Item 5.**Section 4.55 Application: 155 Mitchell Road, Erskineville - D/2015/966/G**

File No.: D/2015/966/G

Summary Recommendation: The Section 4.55(2) modification application is recommended for approval, subject to conditions.

Figure 16: Proposed ground level setbacks (3m to Block E - outlined by red dashed lines and clouded)

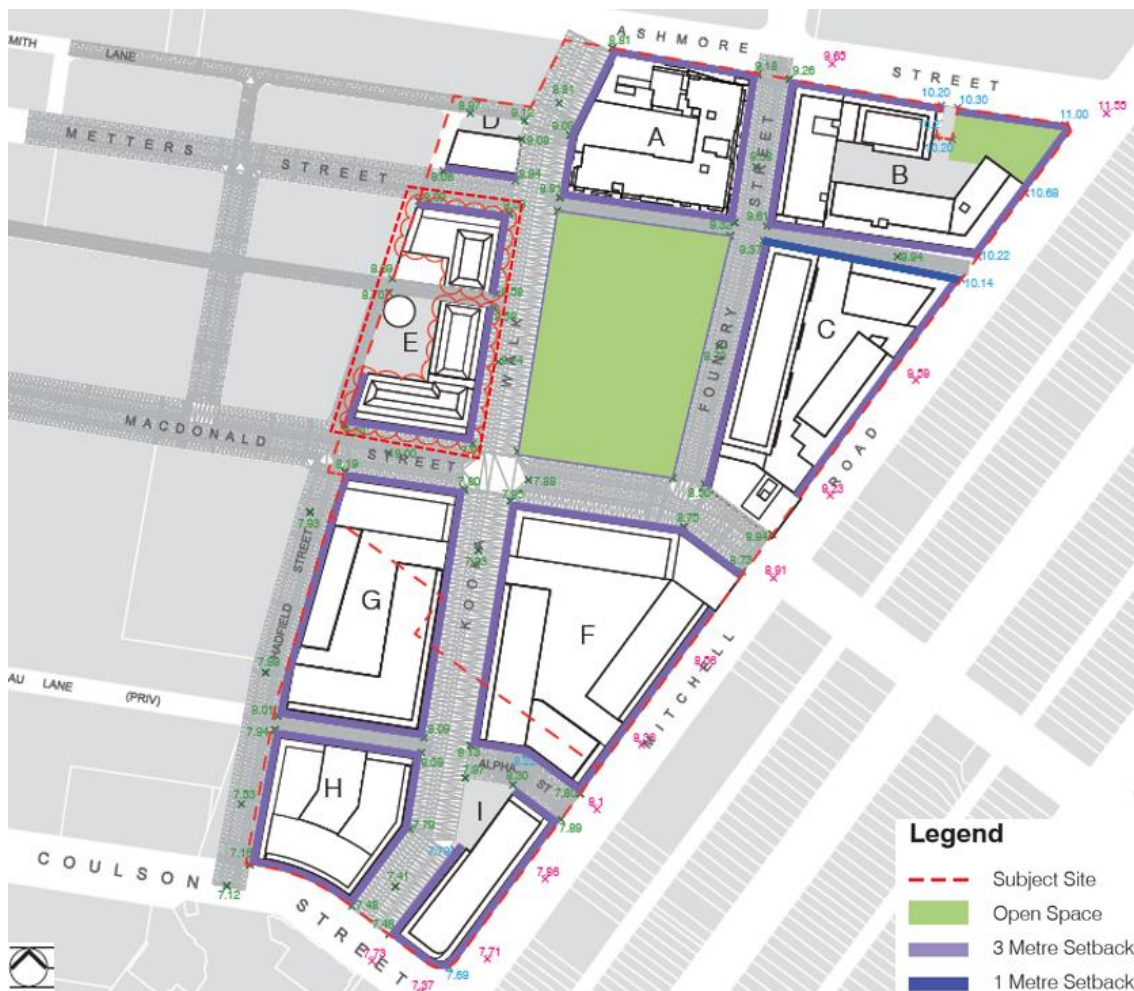
28. The Section 4.55(2) modification seeks to amend the concept approval to bring it in line with the subsequent detailed design development application.
29. The application modifies the existing concept envelopes for Block E as follows:
 - (a) increase the height of the southern wing (facing the new Macdonald Street extension) of the second residential flat building envelope from 7 storeys to 8 storeys;
 - (b) increase the height of the western elevation of the first residential flat building envelope from 5 storeys to 7 storeys
 - (c) introduce a mansard roof form across the site above the 8th storey;

- (d) Changes to overall height of the building envelopes as described below:
 - (i) increase in height to top of mansard roof east elevation of first residential flat building from 28.01m to 30.095m;

- (ii) increase in height of top of mansard roof east and southern elevation of second residential flat building from 28.07m to 30.87m;
 - (iii) reduction in height of top of 7th storey at northern elevation of first residential flat building from 24.91m to 23.96m;

- (iv) reduction in height of top of 7th storey at eastern elevation of second residential flat building from 24.79m to 23.84m;
- (e) Changes to the upper level setback above the street wall height from 4m to 3.6m at the southern wing of the second residential flat building; and

- (f) Introduction of a single storey indoor communal pavilion within the central courtyard and single storey level to courtyard of the first residential flat building envelope, at the west elevation.

Figure 24: Proposed height exceedance - from D/2023/842

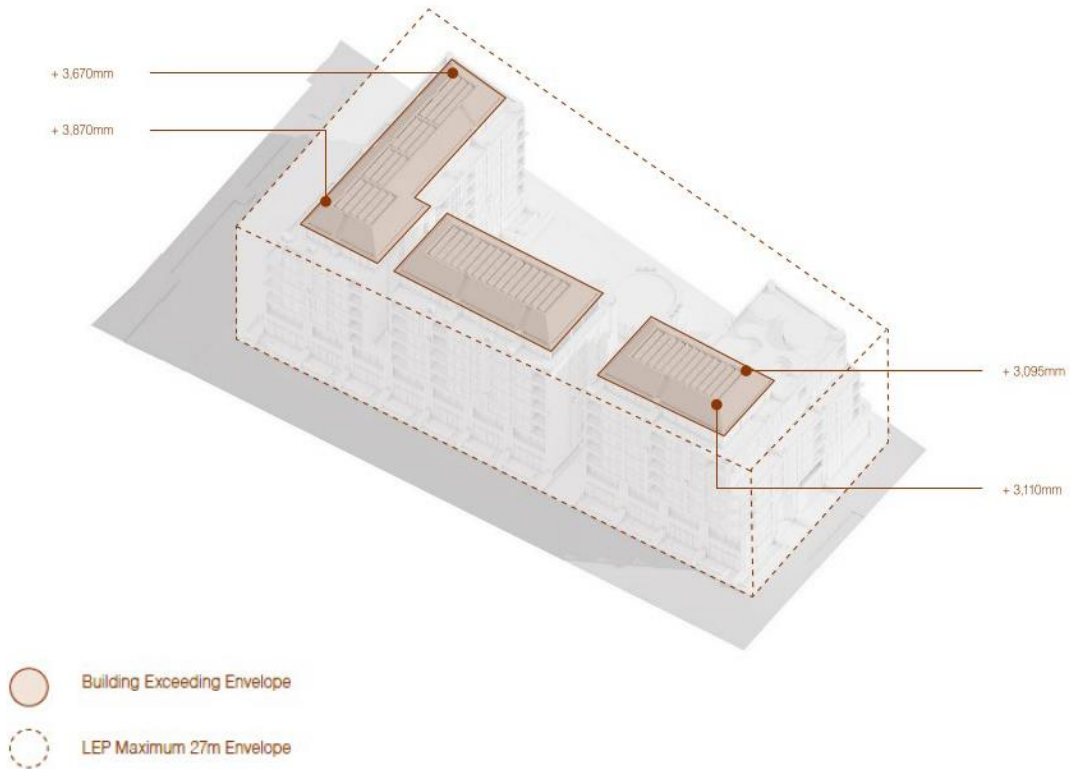
44. The application proposes to exceed the maximum 27m height of buildings development standard by up to 3.87m (14.3% variation), as depicted in the building envelope diagram below. The height in storeys of Block E is also proposed to increase, with the southern wing rising from 7 storeys overall to 8 storeys, and the western elevation from a 5 storey street wall height to 7 storeys.
45. The street wall heights to Metters Street and Macdonald Street will remain at 5 storeys. The street wall height to Kooka Walk will also remain at 7 storeys.

46. The additional height above the 27m height development standard forms part of the detailed design refinement of the roof form, with the introduction of a mansard roof housing plant area.

47. The change to the overall height resulting from the mansard roof was considered to be a key element of the design competition winning scheme. Additionally, the site is flood affected, with the ground floor raised 2.29m above natural ground level to comply with the City's Interim Floodplain Management Policy.

Figure 27: Solar analysis from D/2023/842 demonstrating Concept Modification impacts to Building G and 5 Hadfields Street

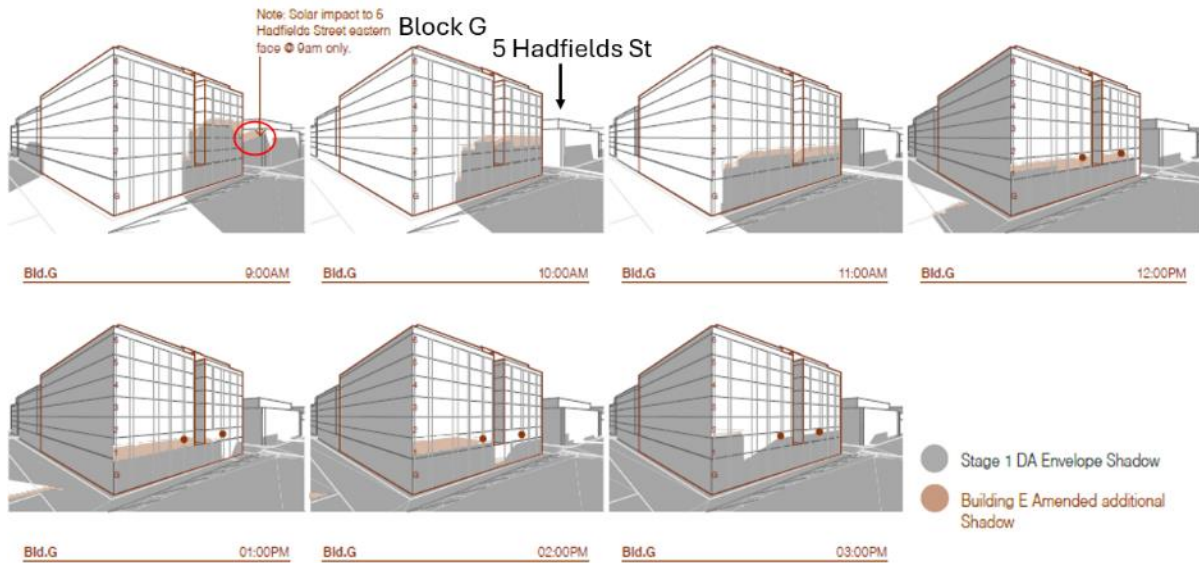
51. The increase in overall height will still allow for Block G to achieve solar access in accordance with ADG requirements at the winter solstice (when assessed against the Design Competition winning scheme). The increase in height will result in some additional overshadowing to the eastern facade of 5 Hadfields Street at 9am at the winter solstice. Noting the affected north-eastern apartment shaded and circled in red in the diagram above still receives direct sun from 9am to 3pm at the northern facade, overshadowing to the eastern facade will not affect solar access compliance for the apartment nor the overall development.

Figure 28: Approved (D/2015/966/C) and proposed (D/2015/966/G) height in storeys for Block E. Changes at the western boundary circled in red.

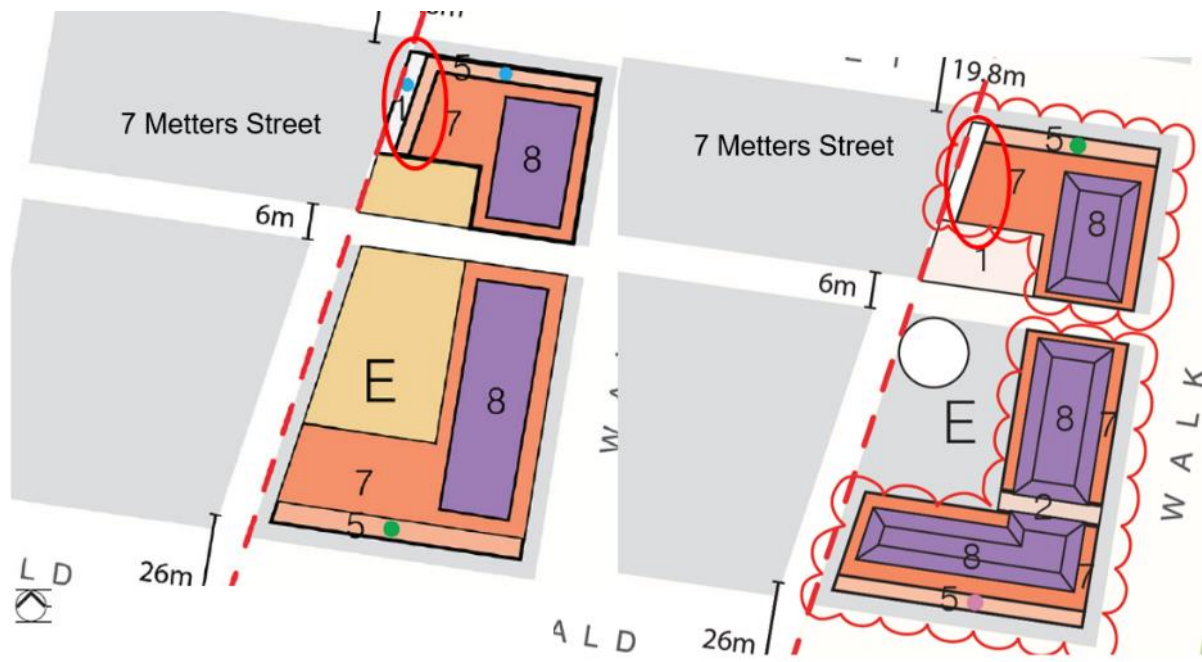
53. The application proposes an increase in height from 5 storeys to 7 storeys at the western elevation of Block E. Directly opposite, is the eastern side elevation of 7 Metters Street, a 5 to 7 storey residential flat building.

Figure 30: Proposed floor plan - Level 6 of Block E (D/2023/842), depicting separation to side boundary with 7 Metters Street

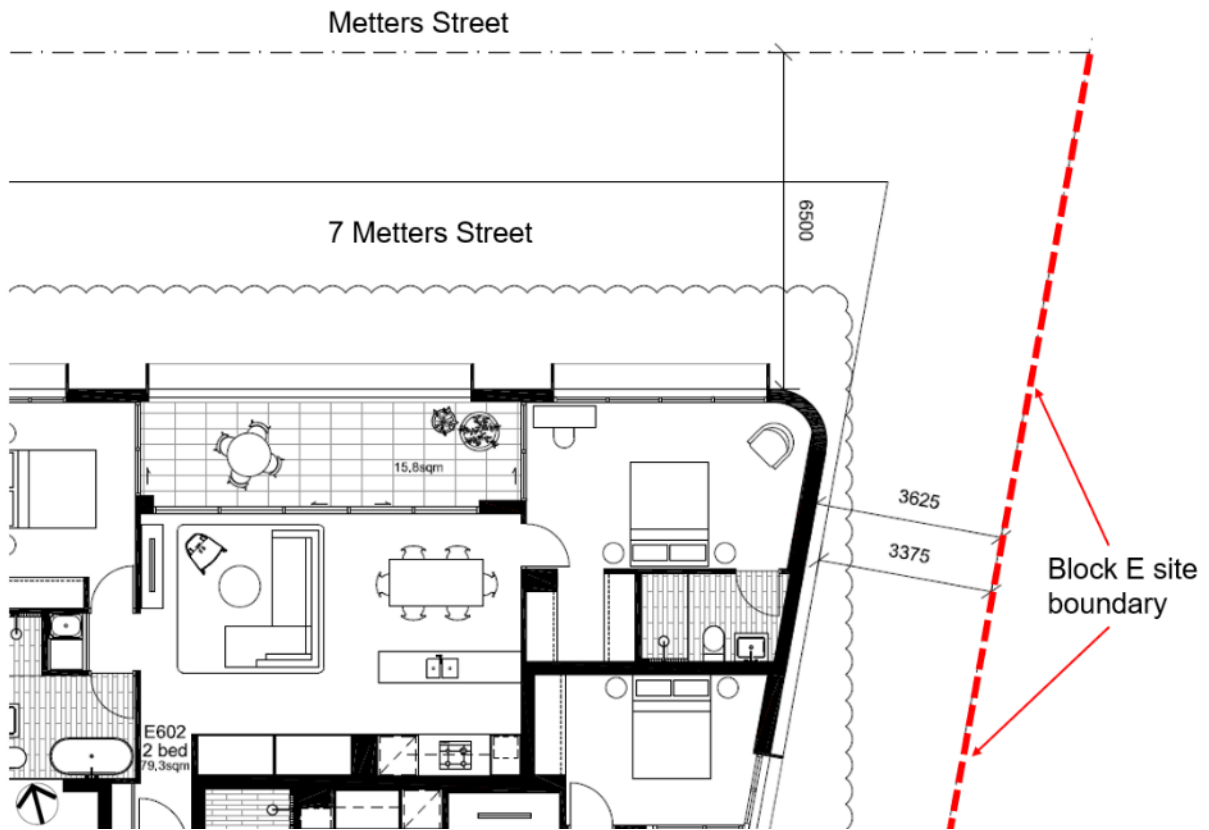
54. From levels 1 to 3, a minimum setback of 6m to the boundary applies where windows to habitable rooms or balconies are proposed, as per Section 2F and 3F of the Apartment Design Guide (ADG). At levels 4 and above, both buildings are required to be setback 9m from the boundary to provide appropriate separation between habitable rooms/balconies. No. 7 Metters Street is 7 storeys at this interface, with bedroom windows and balconies, and a setback of 3.625m to the western boundary of Block E. Block E proposes a setback of at least 3.15m from levels 2 to 6 at the western boundary as part of the detailed design proposal.

Figure 34: Proposed floor plan - Level 6 of Block E (D/2023/842), depicting aligned upper level setback with 74 Macdonald Street

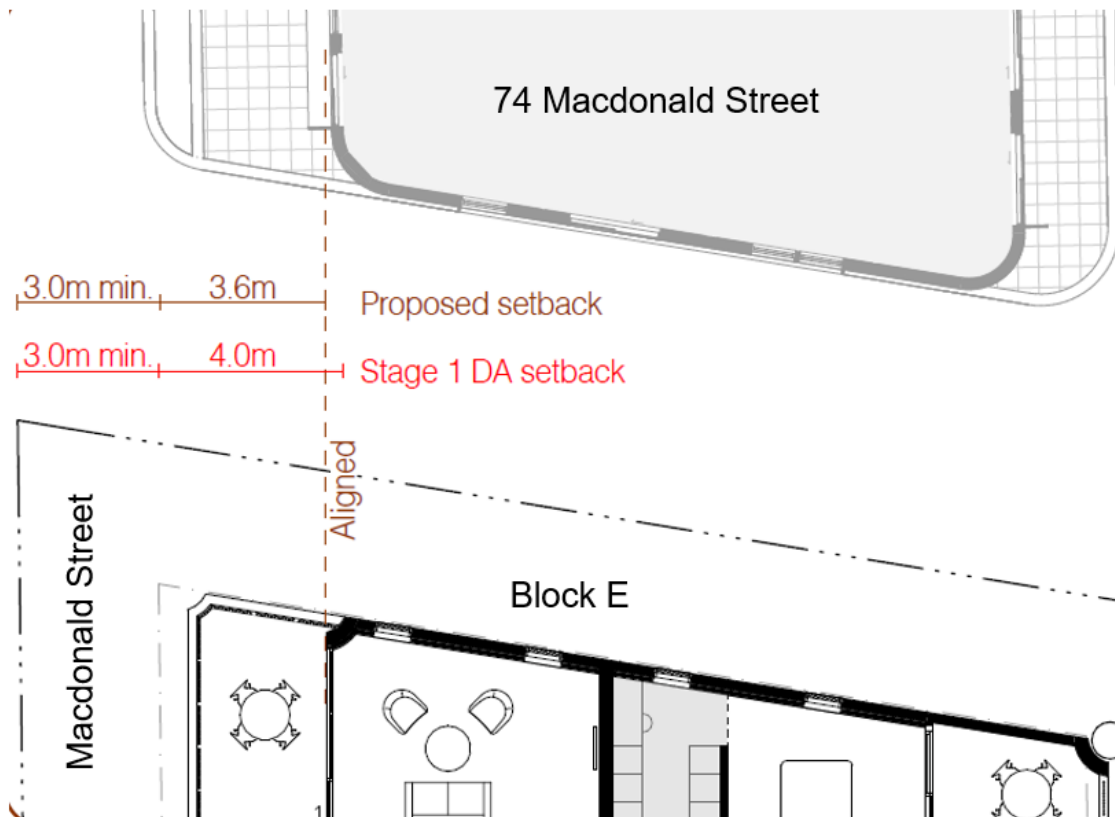
59. The upper level setback variation of 400mm has minimal impact on overshadowing to adjacent properties on Macdonald and Hadfields Streets as discussed elsewhere in this report.
60. The proposed Macdonald Street upper level setback is supported as the intent of the setback, that is, the consistency, scale and framing of the streets, is still achieved by the concept modification.
